**DEPARTMENT OF TRANSPORTATION  
STATE OF GEORGIA**

**FILE:** CSSTP-0006-00(869), Cobb County      **OFFICE:** Engineering Services  
P.I. No.: 0006869  
Big Shanty Connector      **DATE:** January 30, 2009

**SUBJECT: IMPLEMENTATION OF VALUE ENGINEERING STUDY ALTERNATIVES**

## Value Engineering Study Report RESPONSE

Current Section Under I-75 NB Bridge

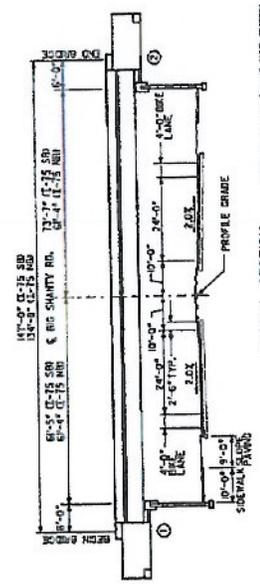
**Description:** Increase clear span under both bridges by 12' to provide for future HOT access. This alternative is to use a wider median on the section of Big Shanty Road under the I-75 bridges so that a pair of parallel left turn bays (westbound left turn for Barrett Lakes Blvd and eastbound left turn for HOT ramp terminal access) could be provided in the median; or reduce the current plan by removing bike lanes, removing one sidewalk, reducing R/W, using MSE wall abutments which would reduce the obligated space and allow for the additional lane without significant impact to the project.

**Response:** Future HOT access for Big Shanty Road has been considered and coordinated for this project. The clear span proposed under the I-75 SB Bridge is currently 116-ft, with 14-ft shoulders on Big Shanty in its current configuration. The clear span proposed under the I-75 NB Bridge is currently 104-ft, with 14-ft shoulders on Big Shanty in its current configuration. With the future addition of a 12-ft Turn lane, shoulders would be reduced to 8-ft under each bridge. Typical sections have been provided in the Calculations Section at the end of this report.

The cost savings calculated by the VE Team was assuming the future demolition and re-construction of the proposed bridges on I-75 due to future HOT access. The originally designed clear span under the bridges should be sufficient to provide for the future HOT access, therefore eliminating the need for future demolition and replacement of the bridges.

VE, I-75 NB & SB  
 OVER BIG SHANTY CONNECTOR

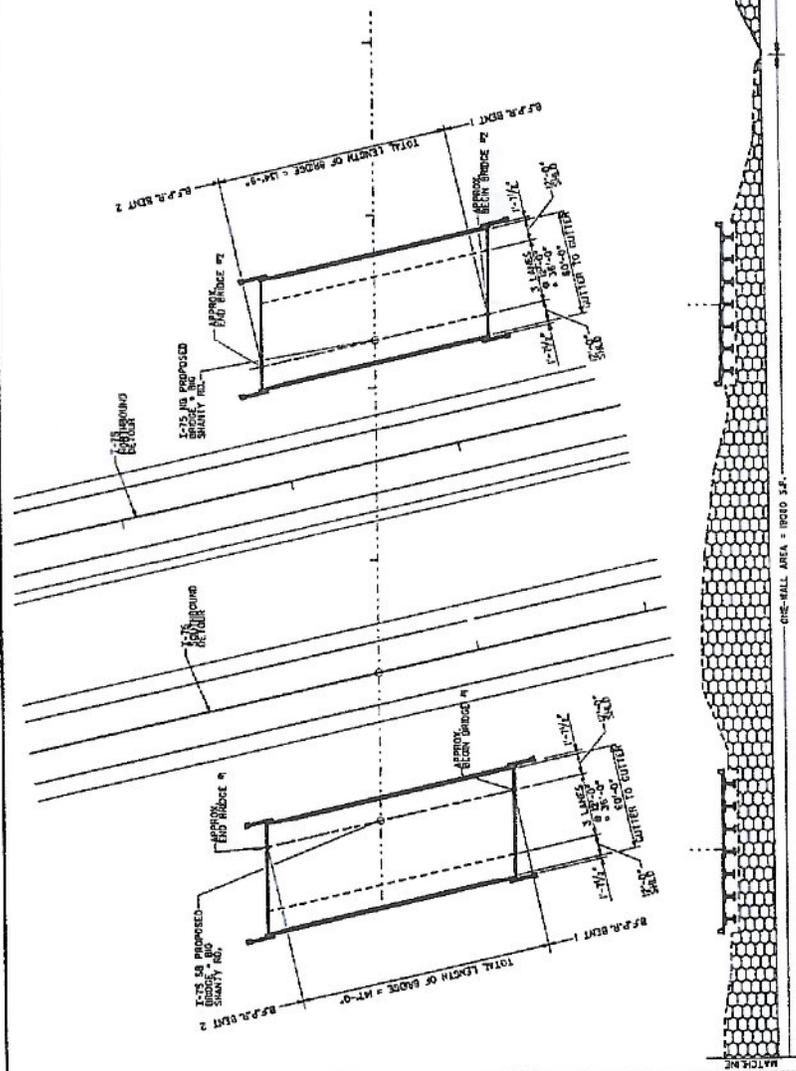
**Description:** Use MSE wall abutments with two, single span bridges without intermediate bents in lieu of the originally designed pair of 3 span bridges with end rolls on each end.

**Response:** Revised Cost Estimates have been provided at the end of this document for the I-75 NB Bridge as designed and with the proposed modifications, as well as for the I-75 SB Bridge as designed and with the proposed changes. We have also included a sheet representing the extents of the required wall abutments. The I-75 NB Bridge was estimated at \$1,211,606 as originally designed and was estimated at \$1,544,031 with the proposed changes. The I-75 SB Bridge was estimated at \$1,328,803 as originally designed and was estimated at \$1,652,532 with the proposed changes. As calculated in our revised estimates, the proposed alternative would actually result in a cost increase of \$656,154.

Also, with the addition of MSE walls, the future HOT access will require shoring and tearing down a portion of the wall as well as constructing additional walls to bring the lanes down to grade.
